SERVICE BULLETIN

Bulletin 25-163

EQUIPMENT/FURNISHINGS - Passenger Compartment - Modify Partition Vertically Mounted Emergency Oxygen Boxes.

Revision 1 November 8/74

VERTICALLY MOUNTED OXYGEN BOX - MODIFICATION

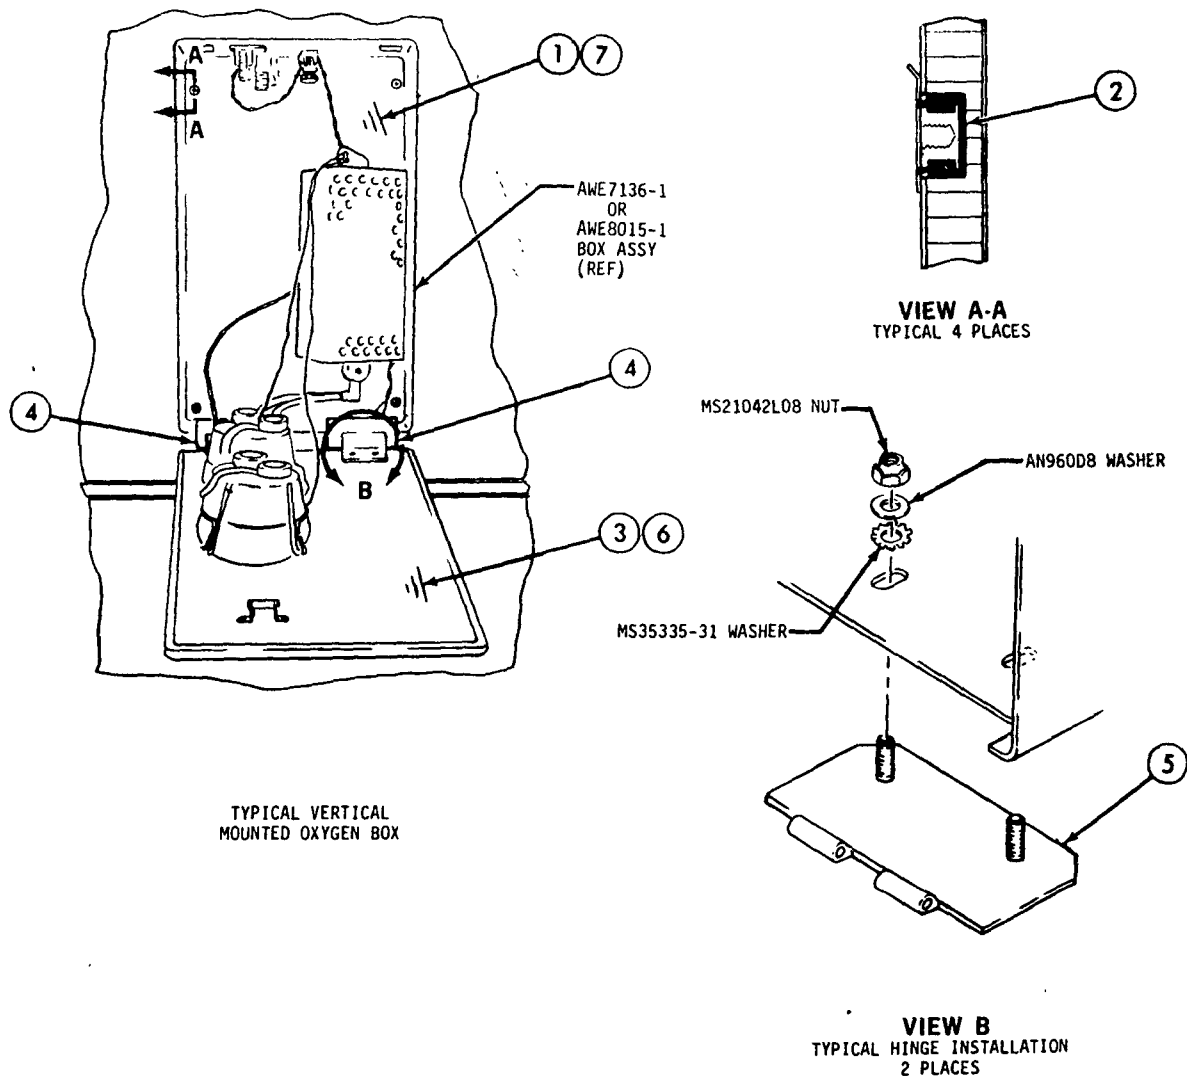
One operator and DAC personnel have reported instances of the vertically mounted passenger emergency oxygen doors not dropping through the full 180-degree deployment. This condition is attributed to difficulty in achieving proper door hinge adjustment. If not modified, the door may not fully deploy, restricting the passage space between the partition and passenger seating. Replacing the oxygen box hinges with hinges that permit adjustment of the door without removal of the box assembly from the partition cavity, will facilitate adjustment and ensure full 180-degree deployment of door.

This modification accomplishes the following at each vertically mounted emergency oxygen box on the divider partitions, galley bustles, and coatrooms, as applicable:

- (1) Replaces oxygen box hinges.
- (2) Installs inserts in partition.

NOTE: THE FOLLOWING INSTRUCTIONS ARE TYPICAL FOR EACH VERTICALLY MOUNTED PARTITION EMERGENCY OXYGEN BOX ASSEMBLY.

- ① REMOVE AND RETAIN EMERGENCY OXYGEN BOX ASSEMBLY FROM PARTITION RECESS. DISCARD ATTACHING PARTS.
- ② INSTALL FOUR SL607-08-75 INSERTS IN PARTITION AS FOLLOWS:
 - a. DRILL OUT FOUR EXISTING HOLES IN PARTITION TO .453/.458-INCH DIAMETER TO A MINIMUM DEPTH OF .397 INCH.
 - b. INSTALL INSERTS USING SLE3009 CASTING COMPOUND. (SEE DOUGLAS PROCESS STANDARD 1.902, TYPE 2.)
- ③ REMOVE DOOR FROM OXYGEN BOX ASSEMBLY. RETAIN HINGE PINS.
- ④ REMOVE TWO AWE7133-11 HINGES AND ATTACHING PARTS.
- ⑤ INSTALL TWO AWE7133-13 HINGES USING FOUR MS35335-31 WASHERS, AN960D8 WASHERS, AND MS21042L08 NUTS.
- ⑥ INSTALL DOOR ON OXYGEN BOX ASSEMBLY USING RETAINED HINGE PINS.
- ⑦ INSTALL OXYGEN BOX ASSEMBLY IN PARTITION RECESS USING FOUR AN960D8 WASHERS AND NAS5302-6 SCREWS.
